Access Compliance Report

Public Rights-of-Way

(Curb Ramps)

Intersection ID: 10024493	Main Street: CROWNPOINT_EXECUTIVE_DR	Cross Street: N/A	Location:	N
ADA ID: BB53F5DAD877	Ramp Type: PerpDiag	Initial Pass/Fail: Fail	Overall Compliance: No	Severity Score: 12.5
Codes/Mitigation Info/Possible Solution		Field Measurements/Component Compliance

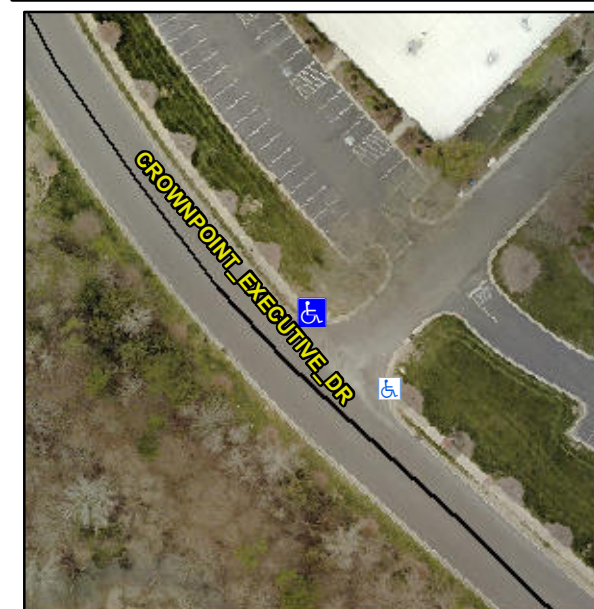
Not Found, R304.5.3

Compliance	Description	Data	Compliance	Description	Data
N/A	Ramp Length (in)	48.0	Yes	Ramp Slope (%)	6.6
Yes	Ramp Width (in)	48.0	No	Ramp XSlope (%)	5.4
N/A	Flare Type LT	N/A	N/A	Flare Type RT	N/A
N/A	Flare Slope LT (%)	N/A	N/A	Flare Slope RT (%)	N/A
N/A	Flare Traversable LT?	N/A	N/A	Flare Traversable RT?	N/A
N/A	Landing Length (in)	N/A	N/A	DWS Provided?	N/A
N/A	Landing Width (in)	N/A	N/A	DWS Contrast?	N/A
N/A	Landing Slope (%)	N/A	N/A	DWS Length (in)	N/A
N/A	Landing X Slope (%)	N/A	N/A	DWS Full Width?	N/A
N/A	Landing Curb? (Y/N)	N/A	N/A	DWS Offset (in)	N/A
N/A	Shared Landing?	N/A			
N/A	Gutter Ponding?	N/A	N/A	Gutter Slope (%)	N/A
N/A	Gutter Lip Ht (in)	N/A	N/A	Gutter X Slope (%)	N/A
N/A	Painted X Walk1?	No	N/A	Painted X Walk2?	No
	X Walk 1 Direction	To SW		X Walk 2 Direction	To SE
N/A	X Walk 1 Width (in)	N/A	N/A	X Walk 2 Width (in)	N/A
	X Walk 1 Slope (%)	0.7		X Walk 2 Slope (%)	0.2
	X Walk 1 X Slope (%)	1.2		X Walk 2 X Slope (%)	7.2

Remove & Replace Curb Ramp With Two New Directional Ramps or Equivalent.
